**PD Modification Application: MM 24-1044**

**1.0 APPLICATION SUMMARY**

## AGENCY REVIEW COMMENT SHEET

### 2.5 Proposed Site Plan (partial provided below for size and orientation purposes. See Section 8.2 for full site plan)

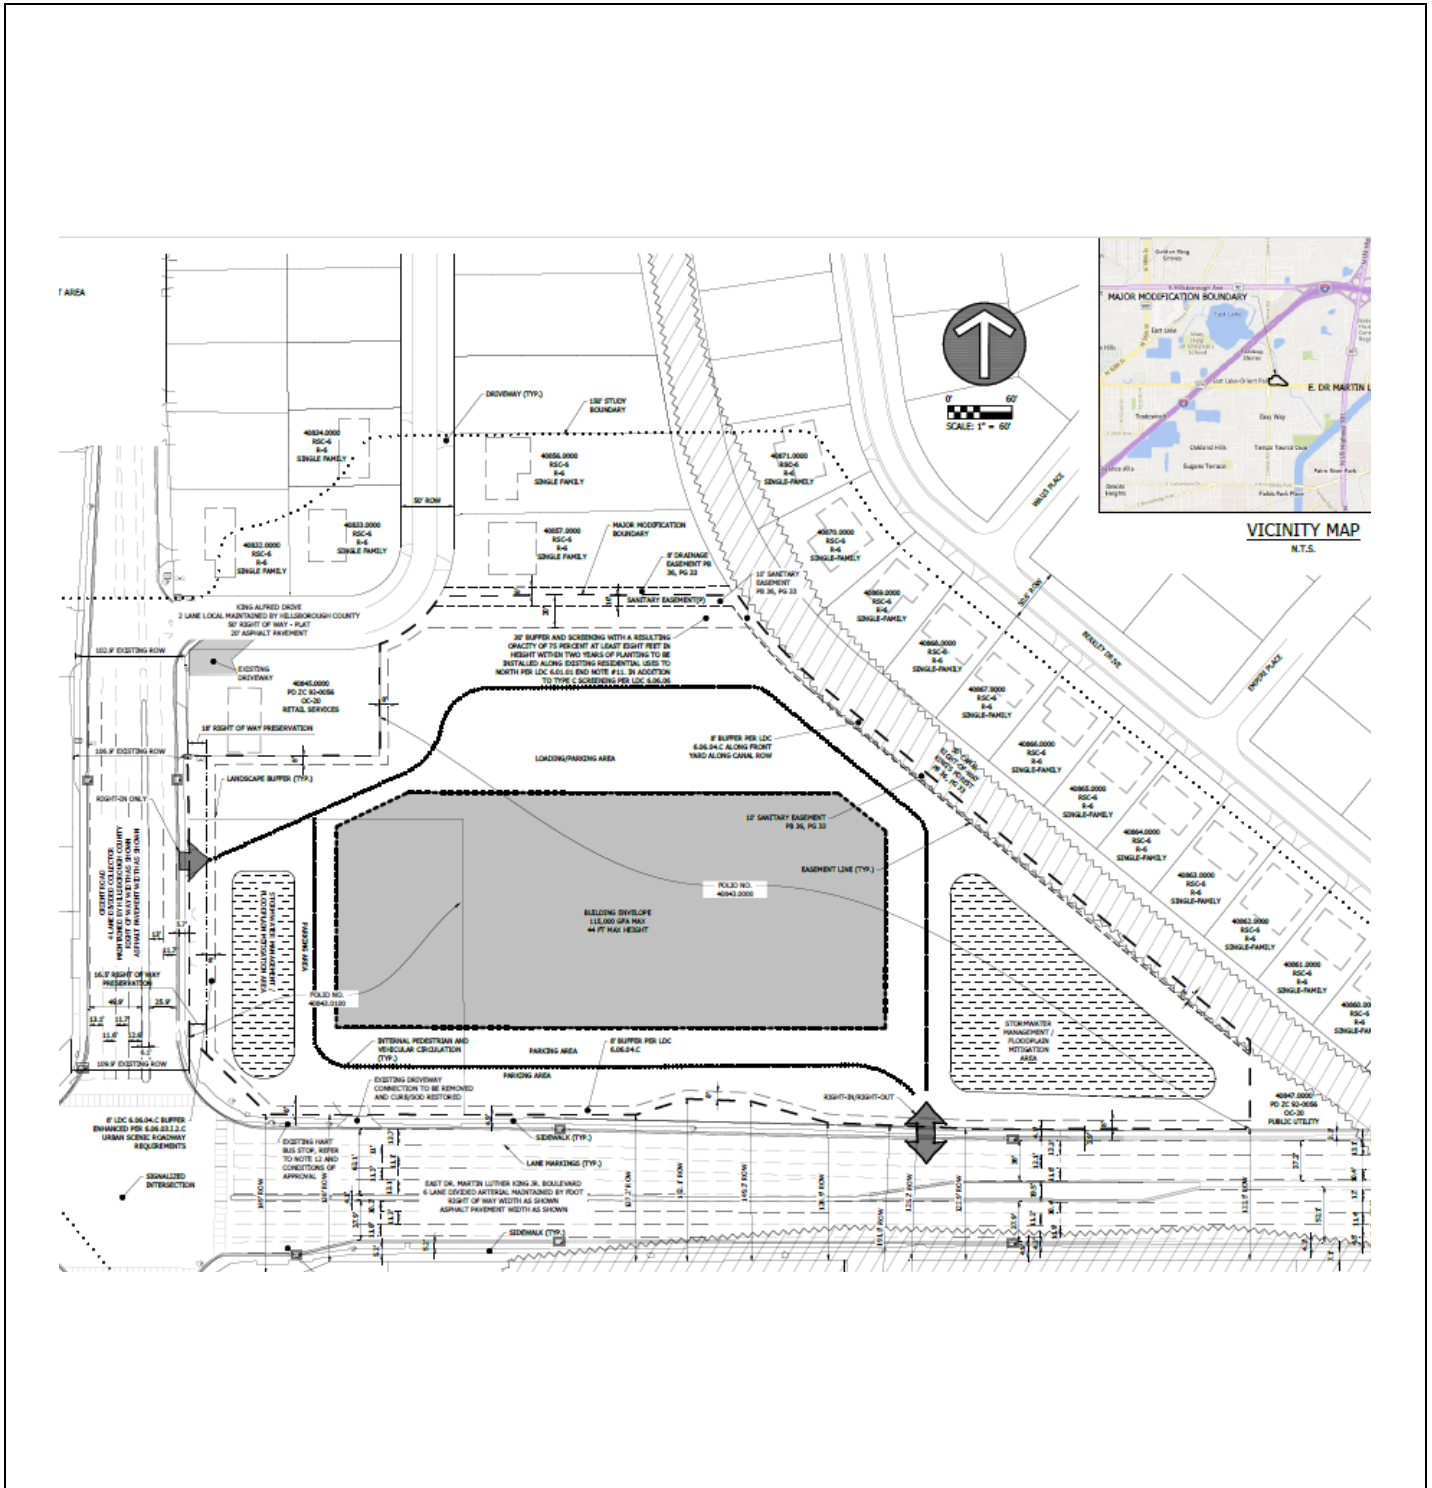
- At the time of site development, the developer shall remove existing driveways identified on the PD site plan, and restore to curb, gutter and sod consistent with the existing roadway section detail.

- Notwithstanding anything shown on the PD site plan or the conditions of approval to contrary, pedestrian cross access shall be provided to the adjacent commercial parcel at the corner of Orient Rd. and King Alfred Dr.

- As Orient Rd. is shown on the Hillsborough County Corridor Preservation Plan as a future 4-lane roadway, the developer shall preserve a range of +/- 16.5 and 18 feet of right-of-way along its Orient Rd. frontage for future improvements, as shown in the PD site plan. Only those interim uses allowed by the Hillsborough County Land Development Code shall be permitted within the preserved right-of-way. Building setbacks shall be calculated from the future right-of-way line.

- Construction access shall be limited to those locations shown on PD site plan which are also proposed vehicular access connections. The developer shall include a note in each site/construction plan submittal which indicates same.

- Prior to certification, the applicant shall revise the proposed PD site plan to include a Planning Note stating that "Parking shall be provided consistent with the County Land Development Code requirements".

TS-6

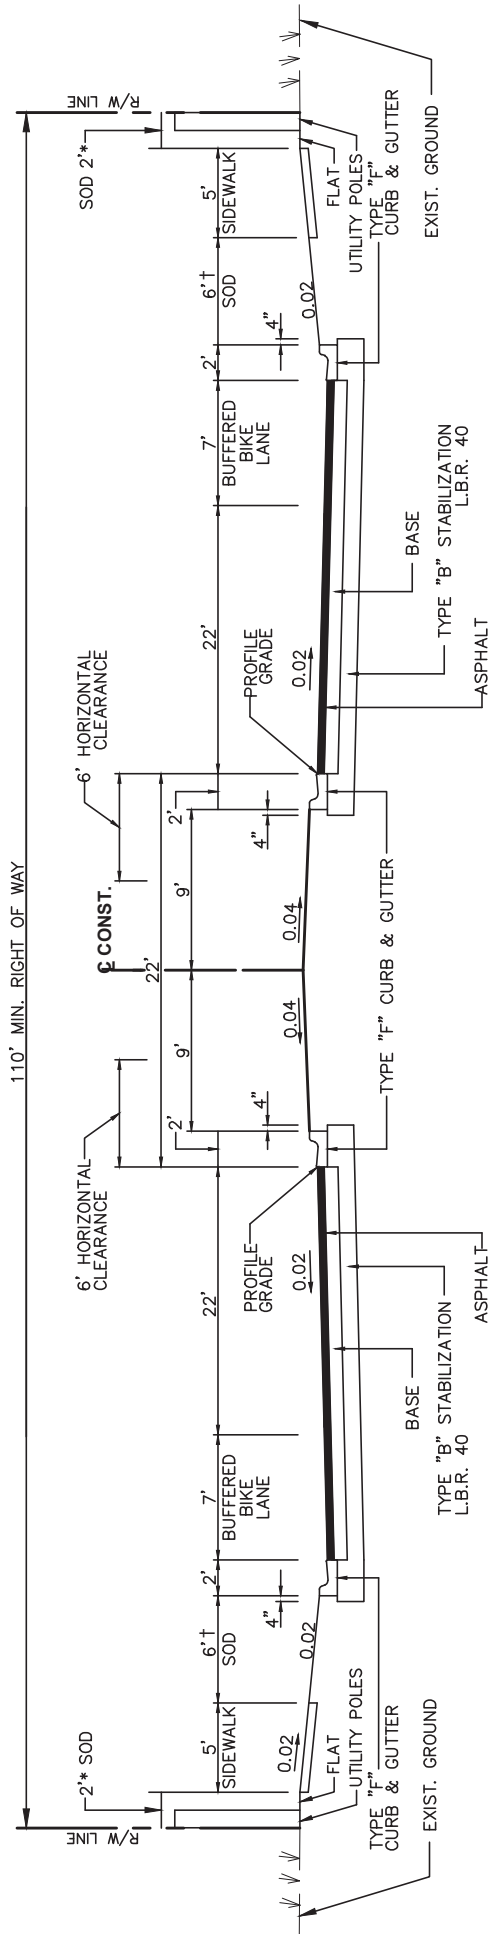
According to the Hillsborough County Transportation Technical Manual a TS-6 urban collector roadway typical section has 11-foot lanes with buffered bike lanes, curb, gutter and sidewalks on both sides within a minimum of 110 feet of right-of-way. The applicant has submitted a Design Exception to make improvements to Orient Rd., consisting of 90 foot northbound right turn lane in to the project site. See additional detail under the section titled "Requested Design Exception" found herein.

The project proposes to provide between 16.5 feet and 18 feet of right of way for future improvements to Orient Road.

The developer does not control the property on the west side of Orient Road and there is not sufficient right of way on the west side of Orient Road to add bike lanes. In addition, there is not sufficient right of way north of the subject parcel to add bike lanes.

CROSS ACCESS EXHIBIT  
MM-23-0904 MLK AND ORIENT INDUSTRIAL  
4015 ORIENT ROAD  
TAMPA, HILLSBOROUGH COUNTY, FLORIDA 33610

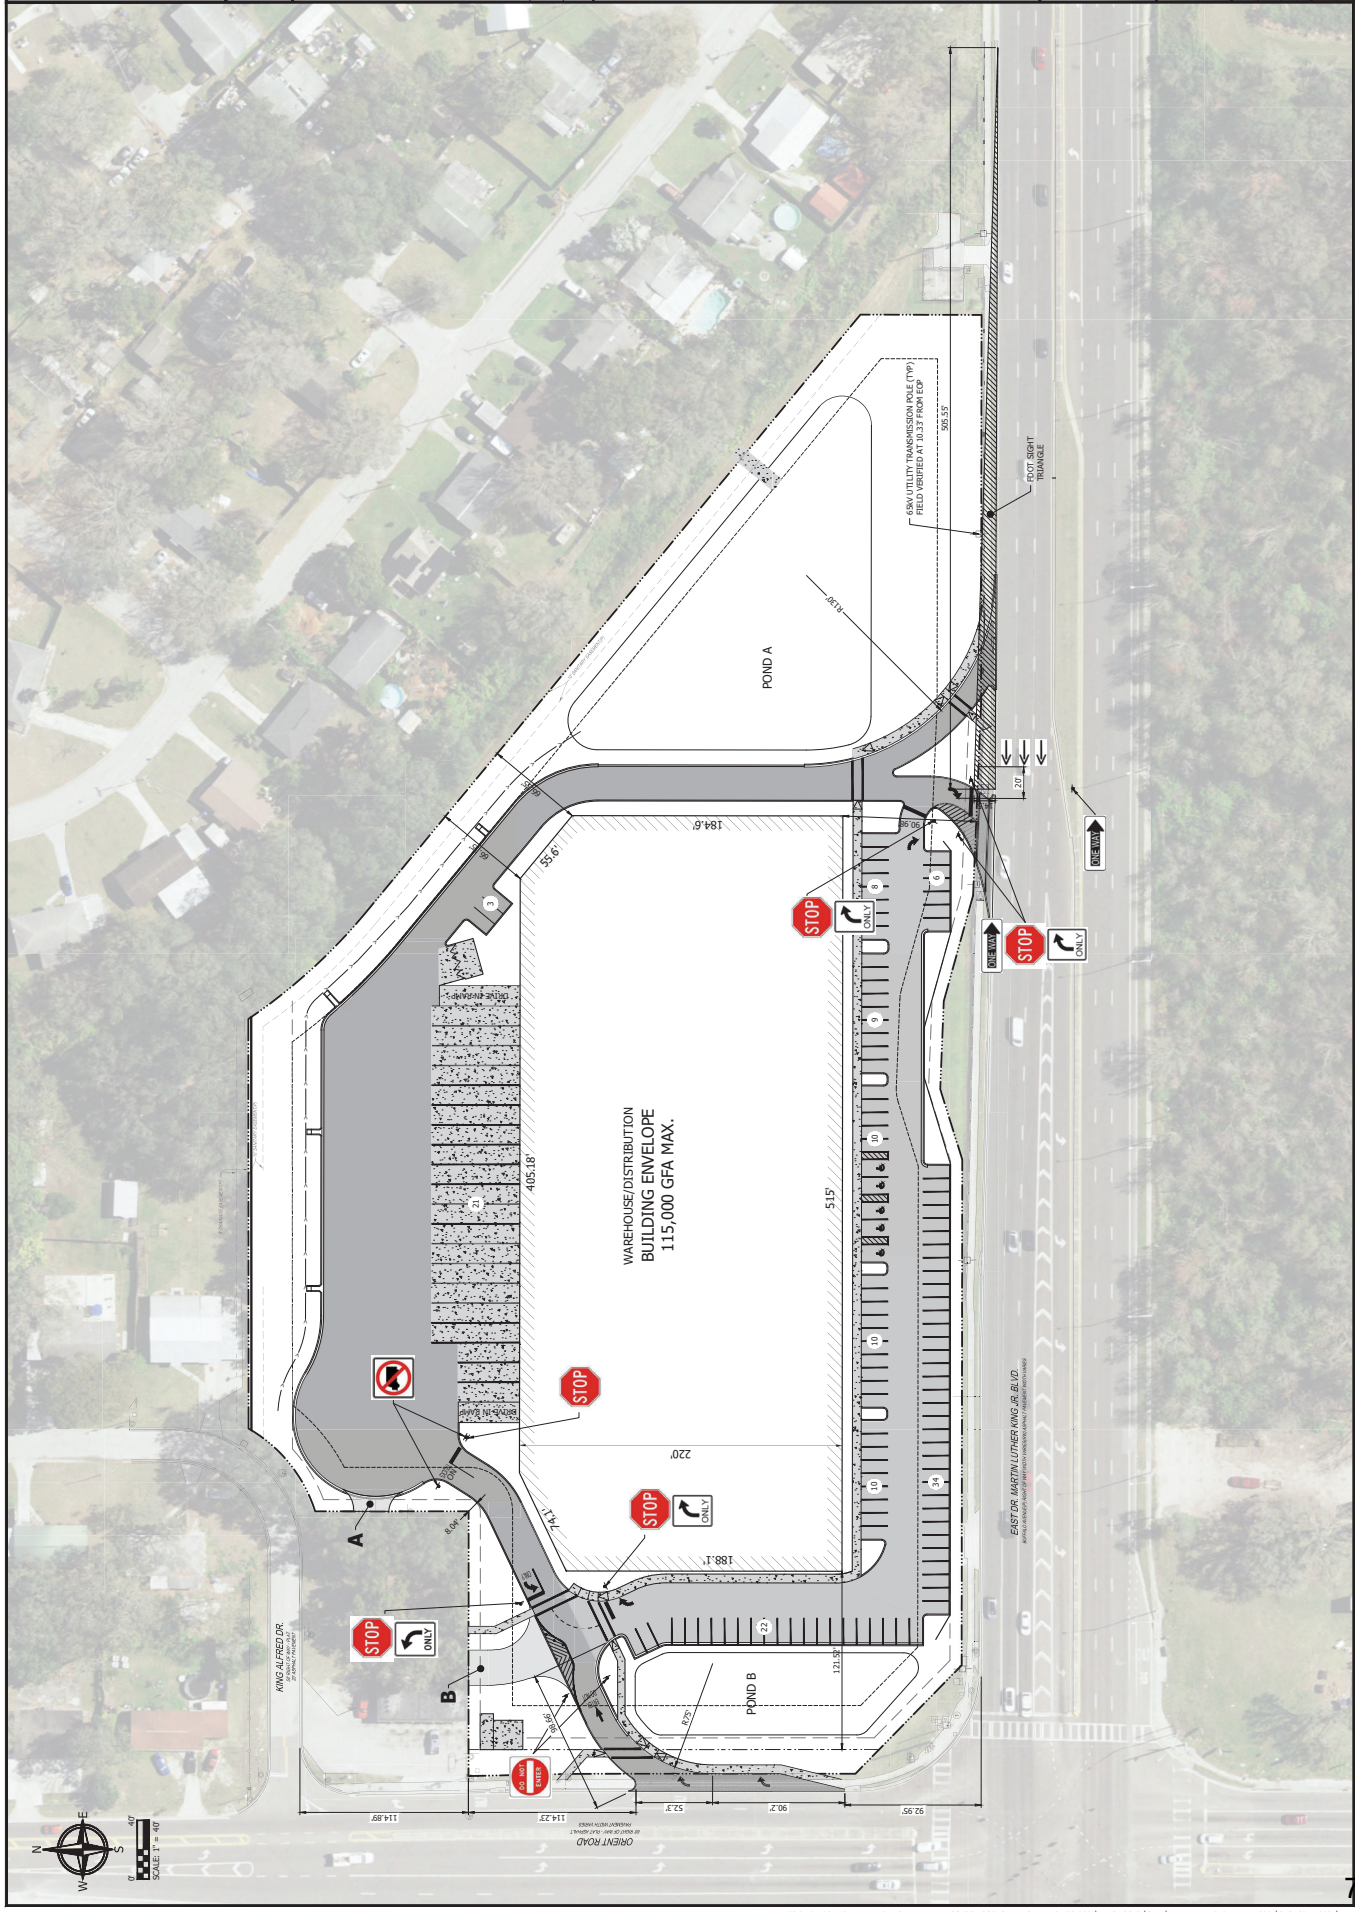
Due to the layout and access configuration for the project, there is not a good location for the cross-access. The cross-access to the west (A) as shown in Figure 1, would require

Given the size of the retail parcel, the amount of cross-access vehicles would be minimal; therefore, it would not be detrimental to the public health, safety and welfare.

Without this variance, vehicles would have to traverse the truck court or potentially impact the access to Orient Road, therefore without the variance, reasonable access cannot be provided.
